# Exhibit 19: Staff Bike Path Proposal

(Corridor 1, Montgomery County)

**NOTE: Staff proposal identified by changes to MDOT proposal as either deletions, or ADDITIONS**

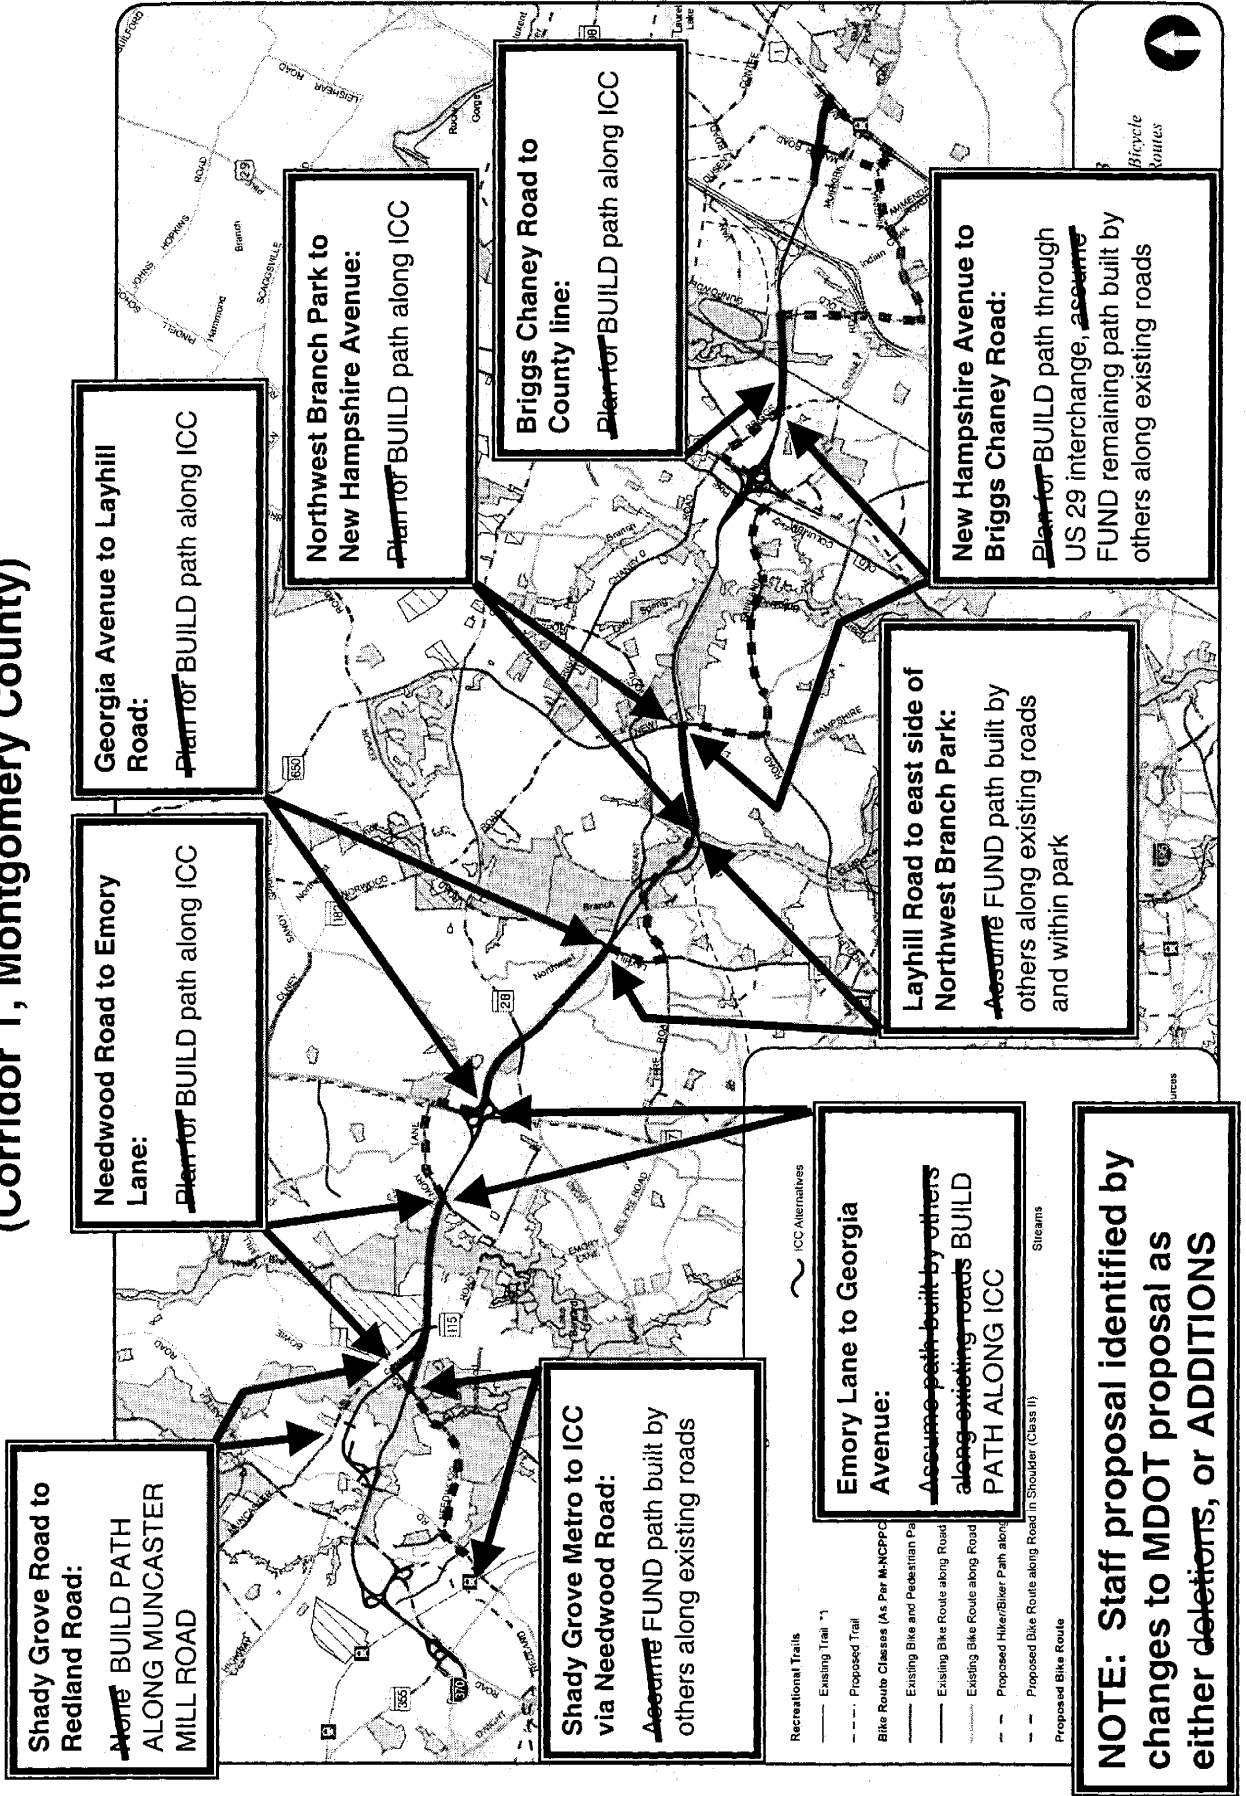
Staff suggests that a compromise to ease concerns regarding both the Section 4(f) impacts and the potential coordination delays could be a partnering agreement in which M-NCPPC constructs the missing portions of park trails through the Rock Creek Stream Valley Park and the Northwest Branch Stream Valley Park. Staff's proposed compromise consists of the following elements, described below and shown in Exhibit 19:

- The selected alternative for Corridor 1 should include construction of the shared-use path along the 7.7 miles of potential trail segments identified as being studied along the ICC right-of-way in DEIS Figure IV-3.

- The selected alternative for Corridor 1 should also include construction of the shared-use path along the one-mile section of the ICC between Emory Lane and Georgia Avenue, including crossing Georgia Avenue at grade at one of the proposed interchange traffic signals and restoring the current shared-use path connection parallel to Georgia Avenue along its west side (using the "old Georgia Avenue" alignment).

- MDOT should commit to locating and providing state or federal funding sources by 2010 to complete the remaining portions of the shared-use path identified as being studied off the ICC right-of-way in DEIS Figure IV-3 (except for the Emory Lane segment replaced by the staff recommendation to augment the Corridor 1 bike path in the preceding bullet). The implementation of these segments using MDOT-acquired funding should be performed by SHA, DPWT, and M-NCPPC according to geographic jurisdiction

- MDOT should also commit to funding a shared-use path along Muncaster Mill Road connecting to the ICC path in the vicinity of Needwood Road and extending northwest to the existing path terminus southeast of Redland Road.
